802.3ar/D1.1

# List of issues

IEEE Std 802.3ae-2002, 4.2.3.2.2

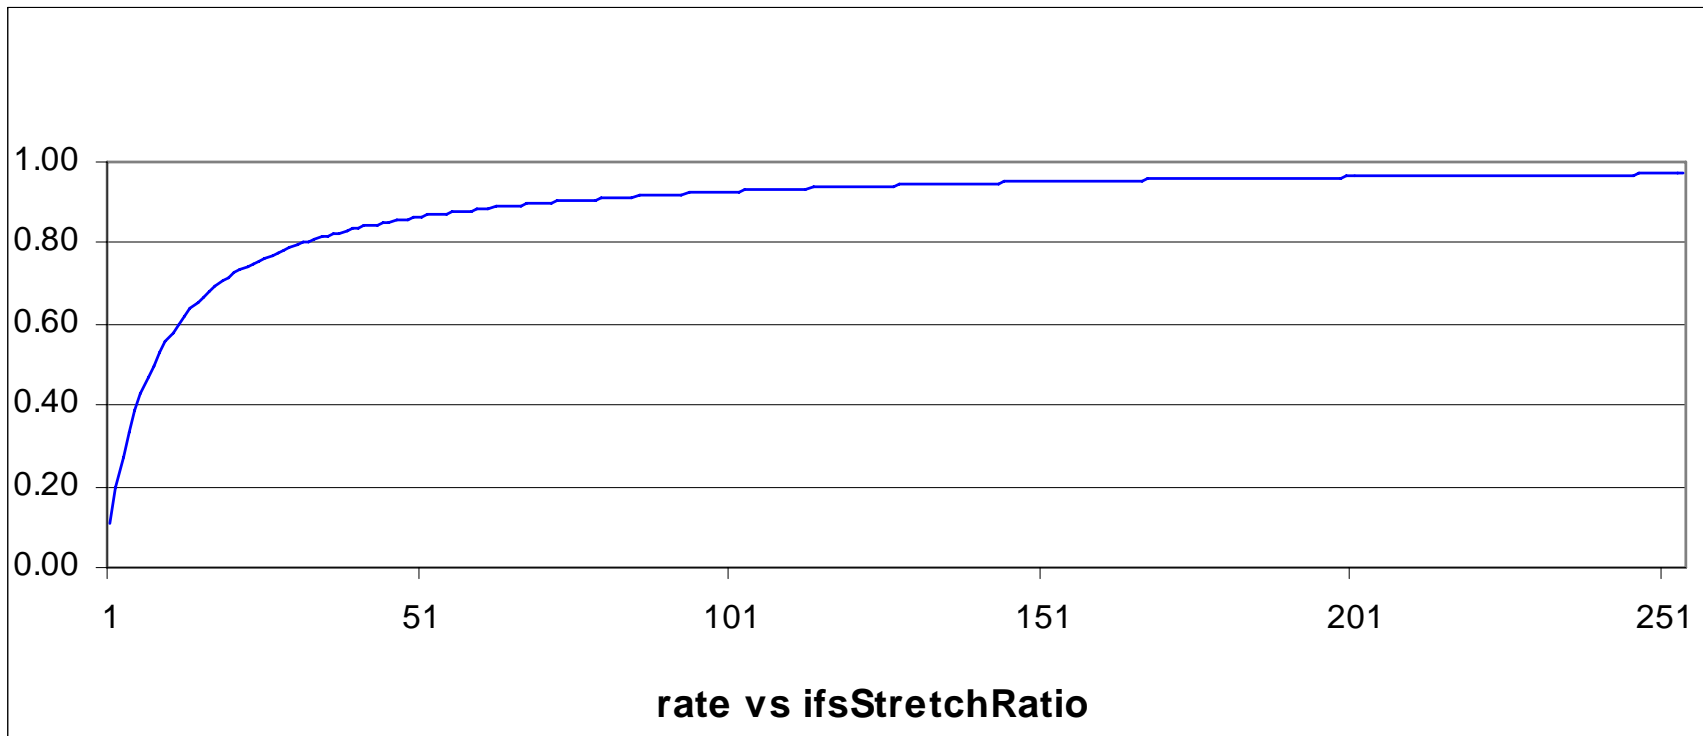
“...dynamically adapting the nominal data rate of the MAC sublayer to SONET/SDH data rates (with packet granularity) for WAN-compatible applications of this standard.”

- It does this very well

# Granularity of ifsStretch

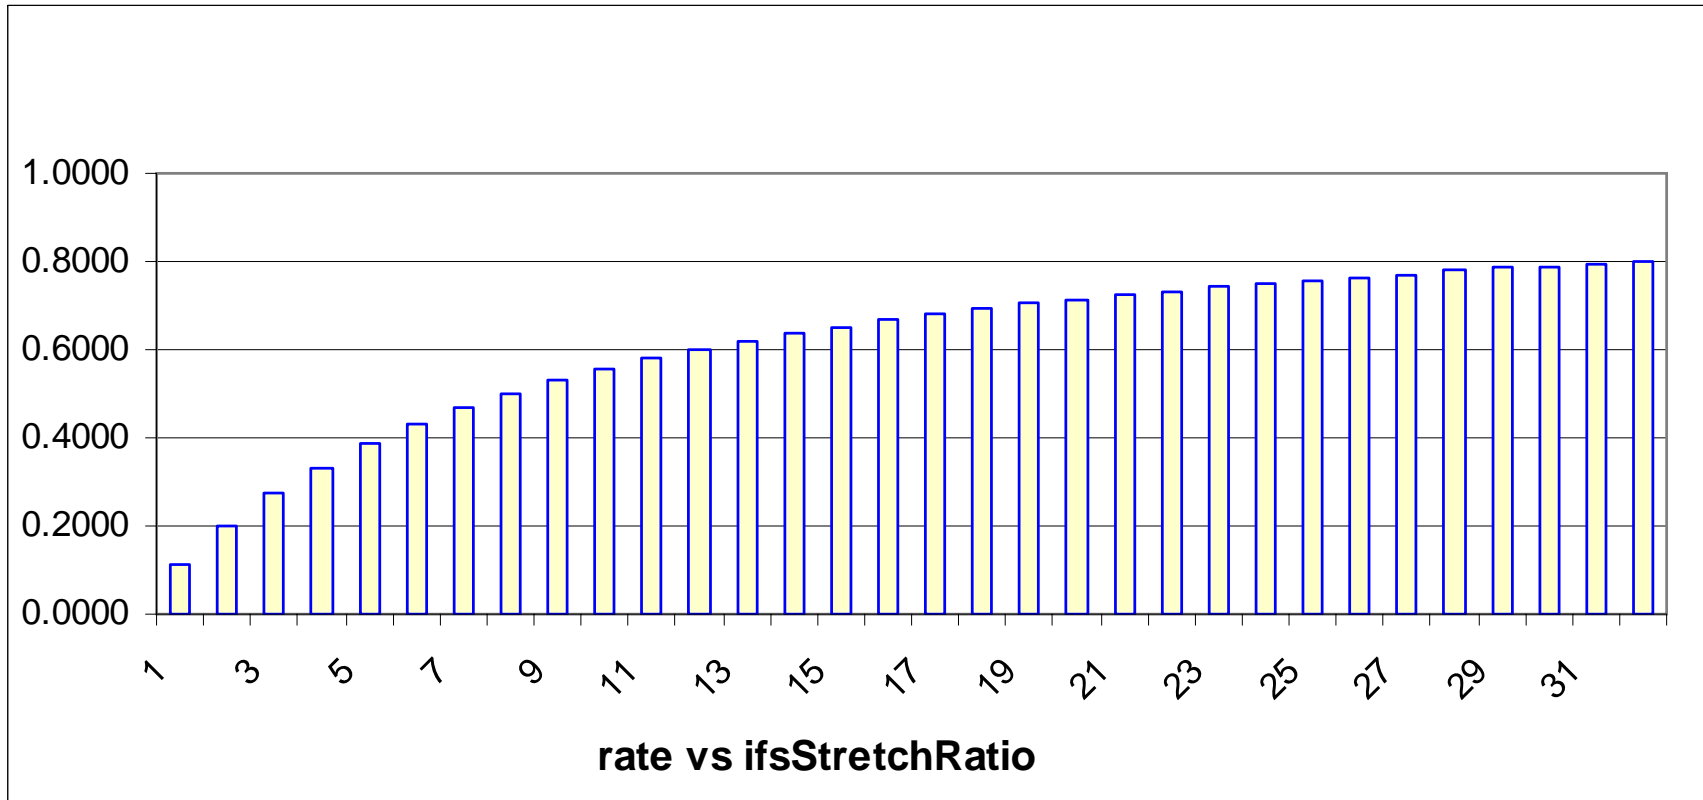
- ifsStretch was not intended to limit the effective data transmission rate to a small fraction ( $< 70\%$ ) of the nominal rate.
- It does this very poorly, because the granularity is quite large

- ifsStretch does not provide a useful means for limiting the effective data rate to a small (<70%) fraction of the nominal rate.
  - not useful for matching 100 Mbps MAC to EFM/DSL/Cable modem
  - not useful for matching 10 Gbps MAC to OC-48
- The bit rate limiting mechanism in the draft does not accomplish what was intended
